HISTORIC AND DESIGN REVIEW COMMISSION

HDRC CASE NO: 2017-223

ADDRESS: 202 SAN ARTURO

TYPE OF WORK: Construction of an addition to a carport structure

REAR VIEW

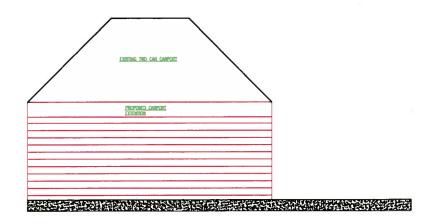
- a. The structure at 202 San Arturo was constructed circa 2008 and features contemporary architectural forms and materials. The structure currently features a carport on the east side to which the applicant has proposed to construct a side addition to serve as a storage location.

- b. The Guidelines for New Construction note that garages and outbuildings should feature a form and mass subordinate to that of the primary historic structure, should feature a building size no larger than forty (40) percent of that of the primary structure, should relate to the period of the construction of the primary building on the lot and should feature windows and doors similar to those found historically throughout the district. Generally, the proposed addition is consistent with the Guidelines; however, the applicant has proposed to install two steel doors. Staff recommends the applicant install doors that feature materials or a profile that are consistent with the architecture of the primary structure.

- i. That the proposed siding feature a smooth finish and a four inch profile.
- ii. That the applicant install doors that feature materials or a profile that are consistent with the architecture of the primary structure.
- iii. That the proposed standing seam metal roof feature panels that are 18 to 21 inches wide, seams are 1 to 2 inches in height, a crimped ridge seam or low profile ridge cap and a standard galvalume finish.
